COVER SHEET  
FOR  
**PUYALLUP PUBLIC SAFETY BUILDING**

PRCCP20030372  
1st Review  
May 2025

COVER SHEET  
FOR PUYALLUP PUBLIC  
SAFETY BUILDING BENAROYA  
TENANT IMPROVEMENT PERMIT/BID SET

C1 of 9

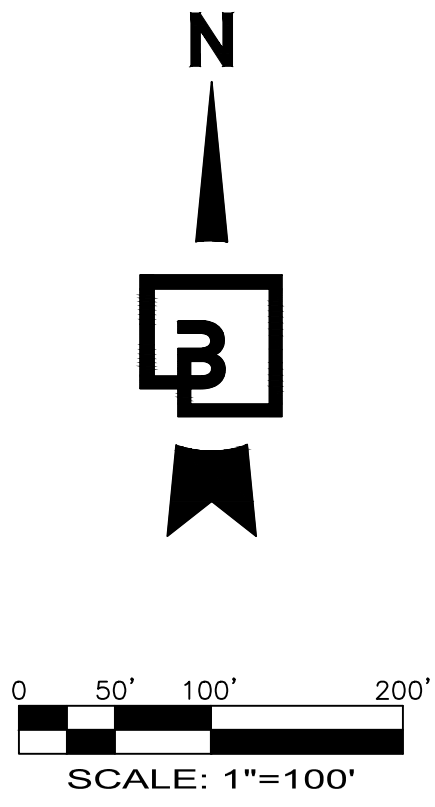
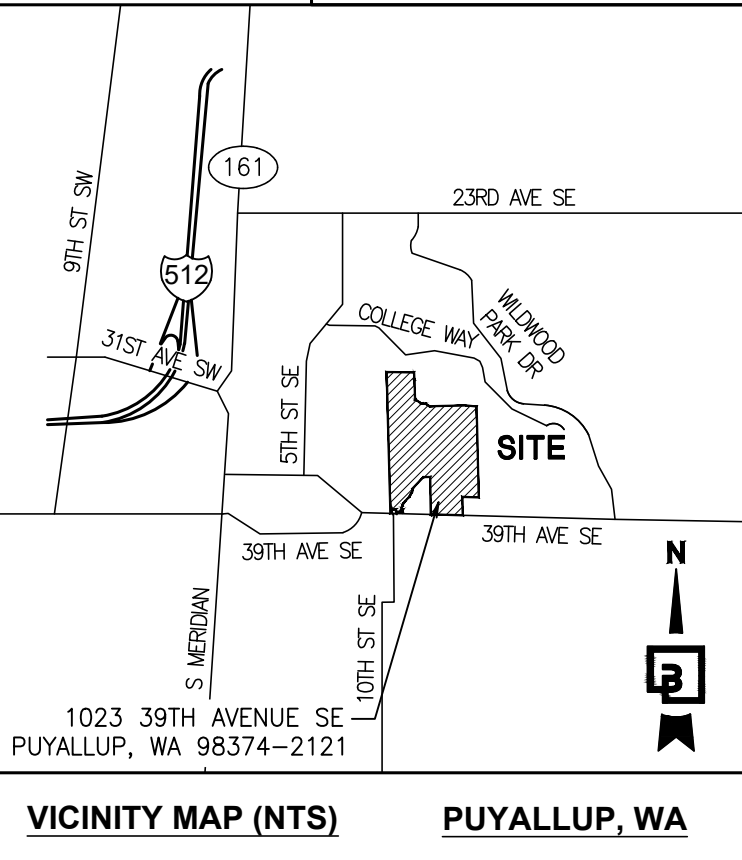
Add Note: "This project being part of an ongoing common plan of development which is greater than 1 acre, a Construction Stormwater General Permit shall be obtained from the Department of Ecology", or similar language.

A NOTE HAS BEEN ADDED TO THE PLANS

Job Number: 23796 Sheet: C7 of 9

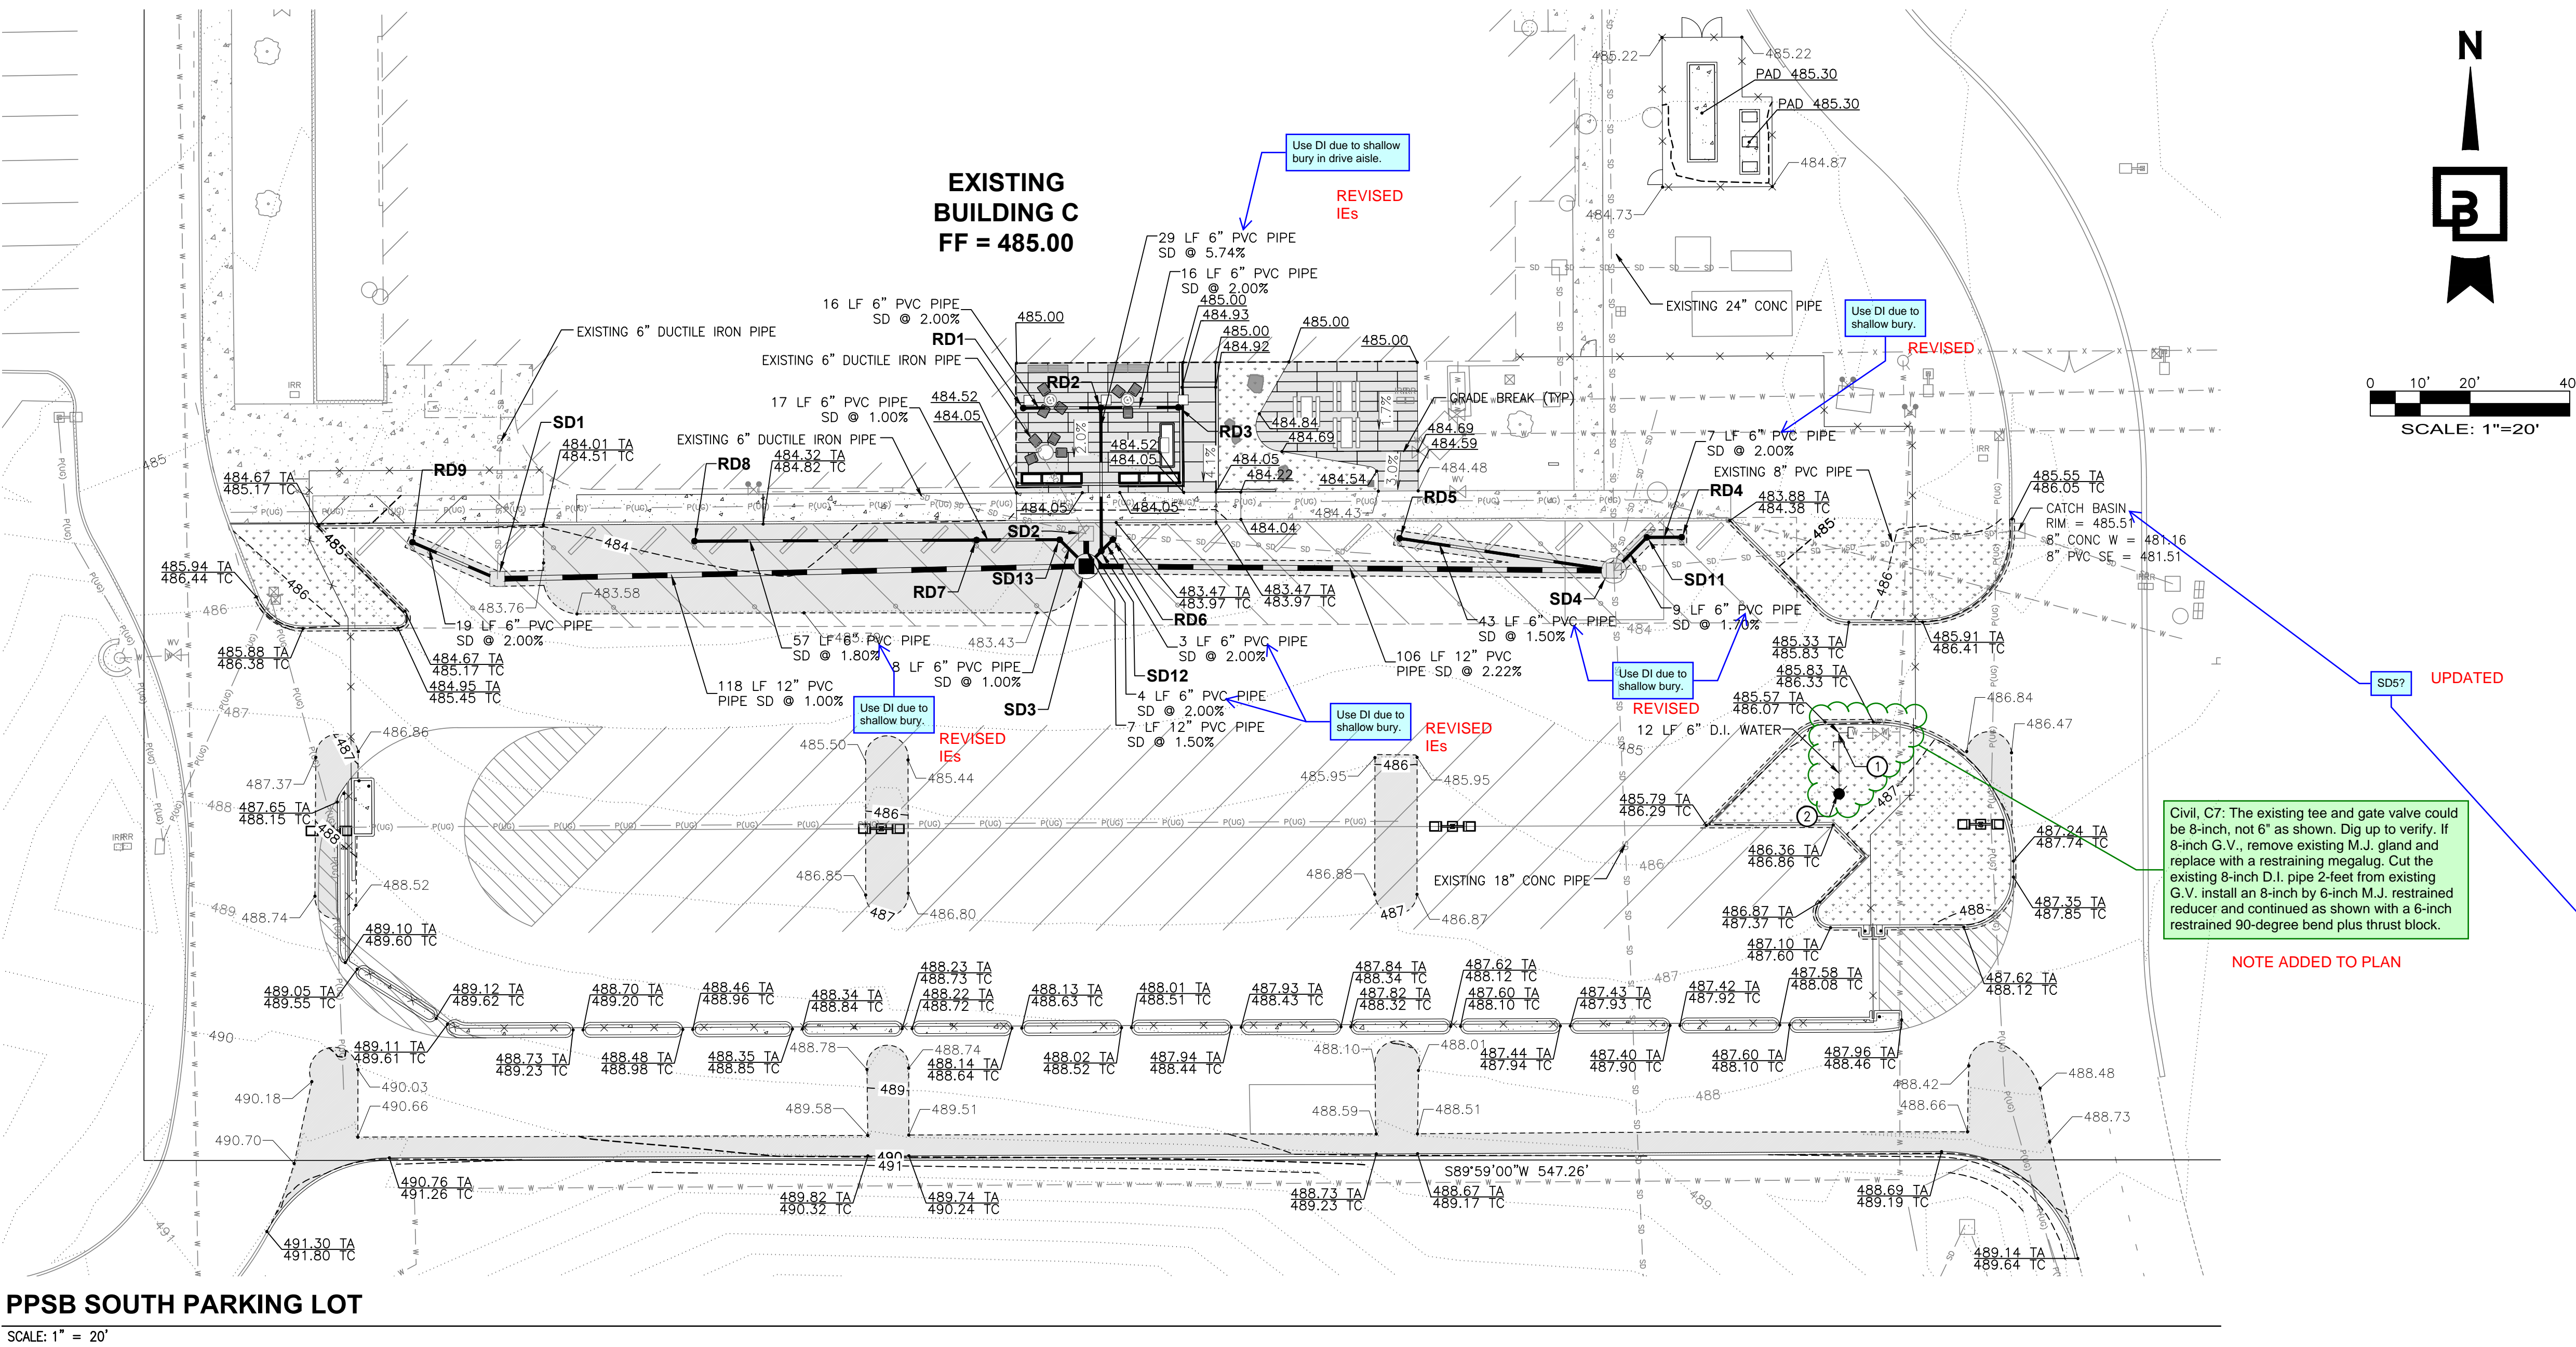
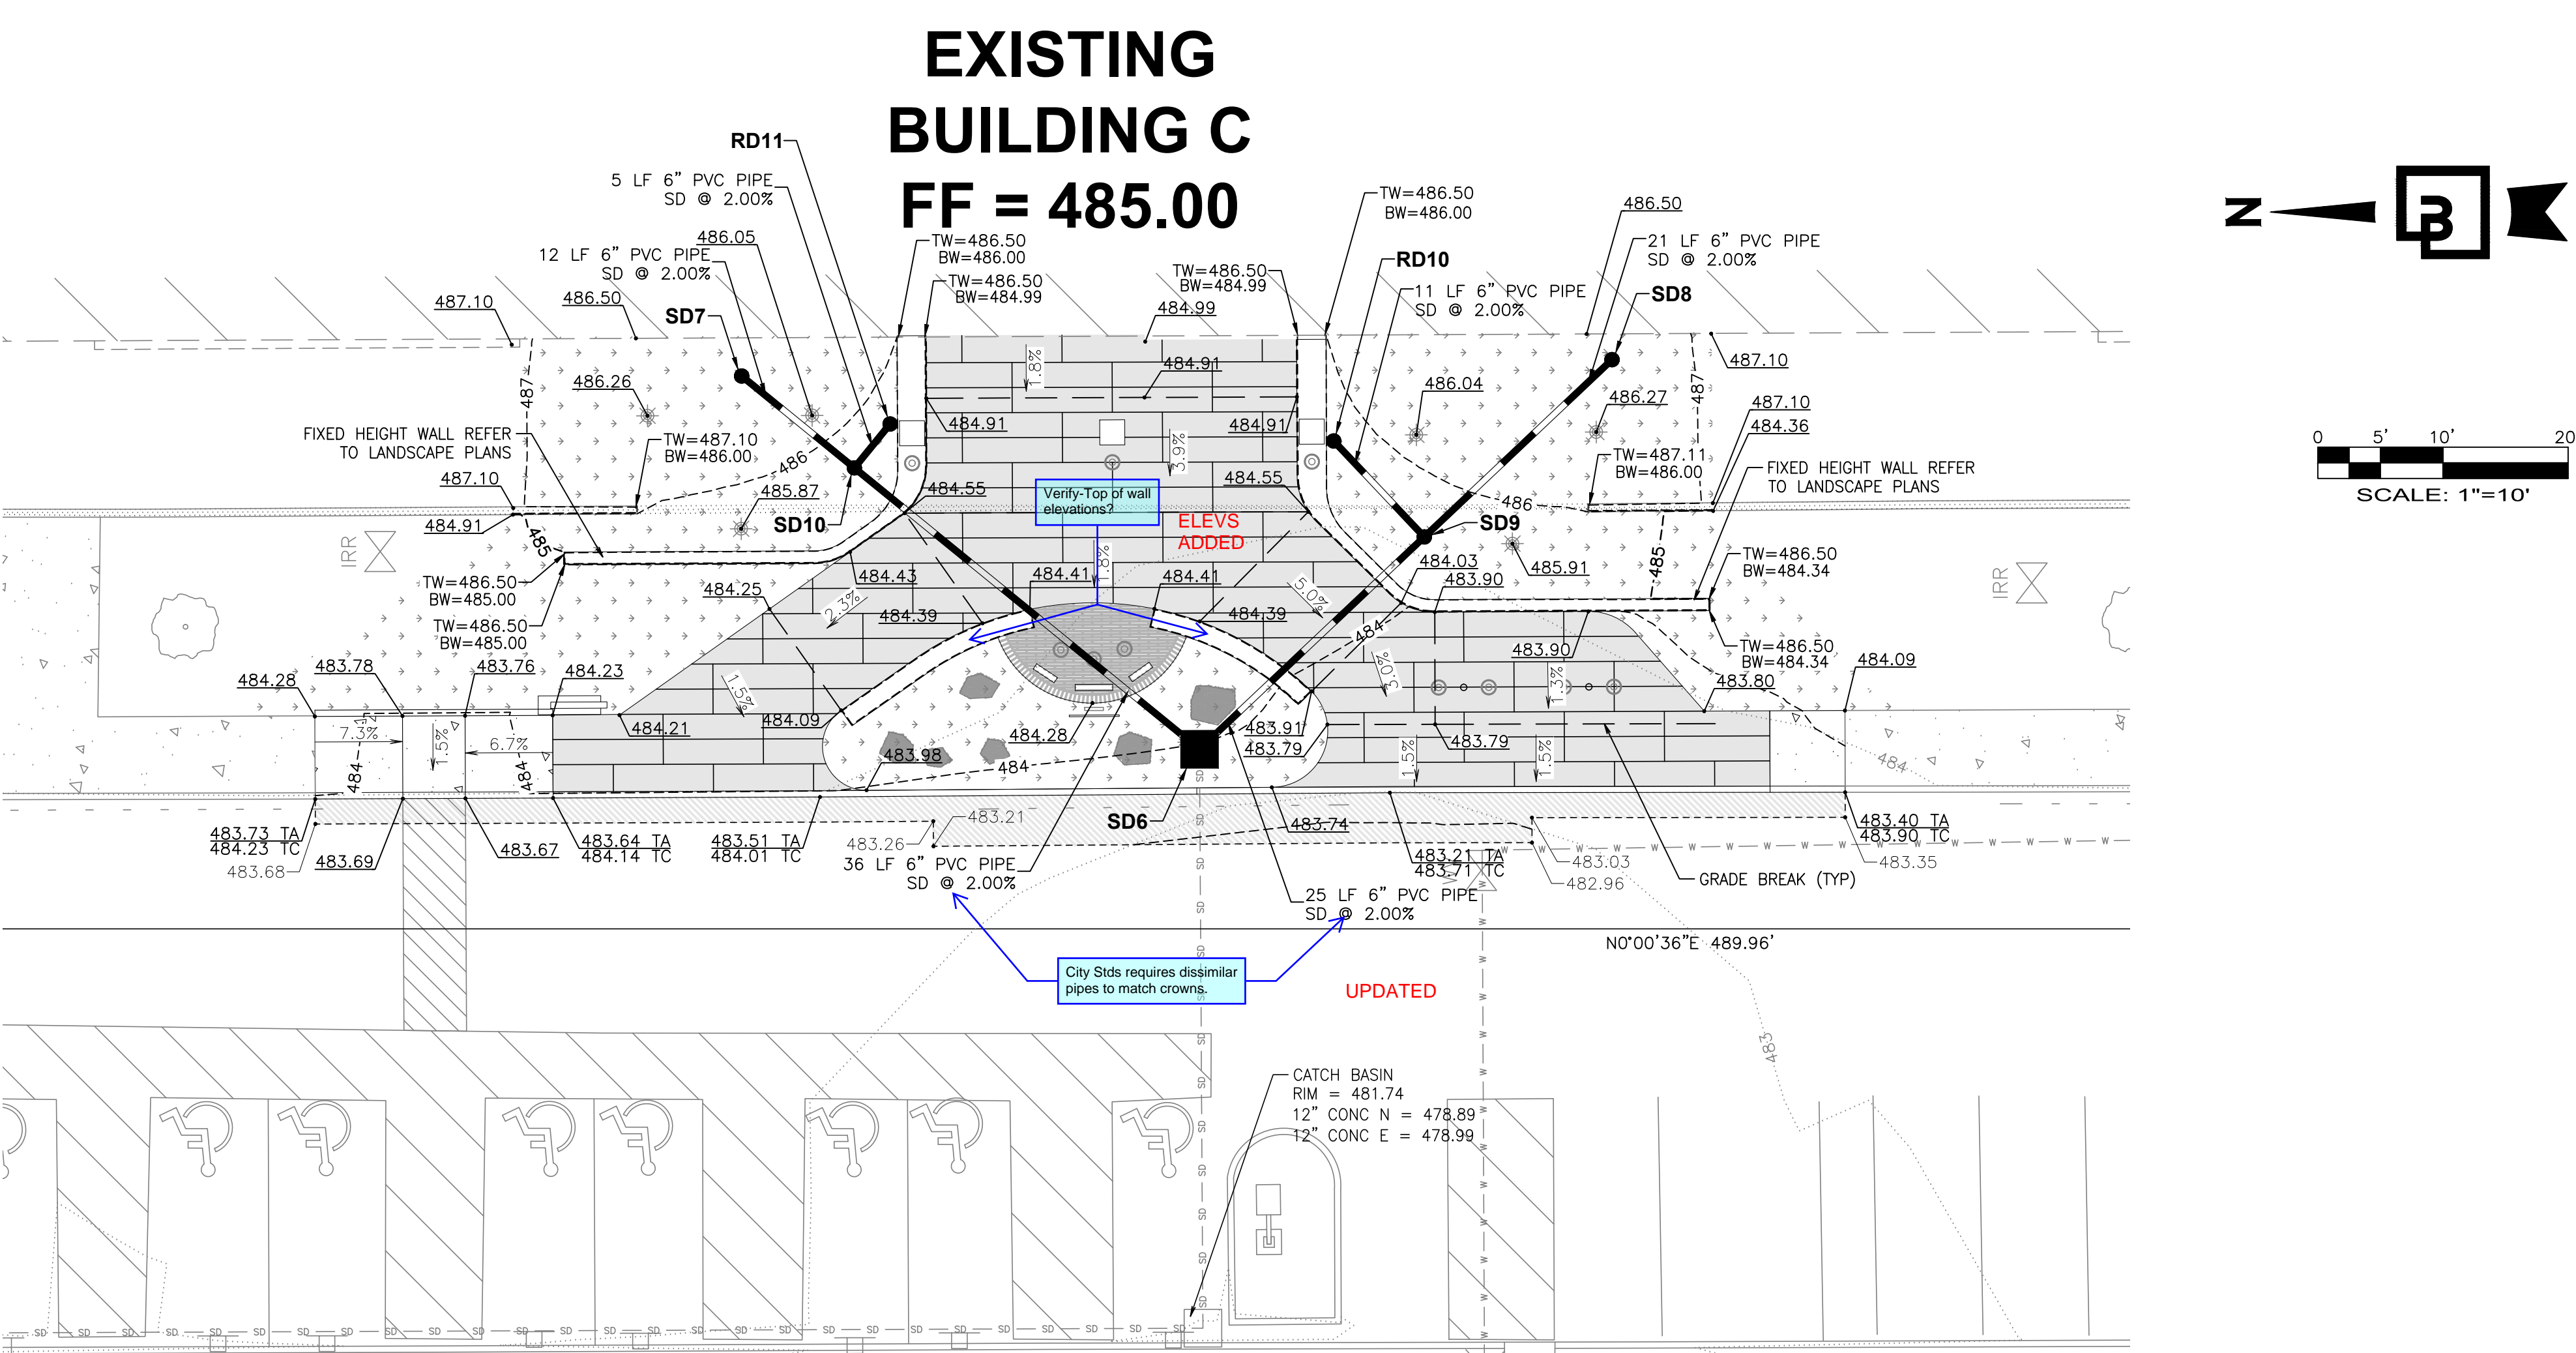
- Match crowns for dissimilar pipes per CS. **REVISED IEs**
- Coordinate IEs w/ Existing CB on Sheet C4. **REVISED IEs**
- Is there a reason the IE cannot be matched per Standards (478.66)? **REVISED IEs**
- Is there a reason that crowns are not being matched as required by Standards? **REVISED IEs**
- Lid info? **ADDED**
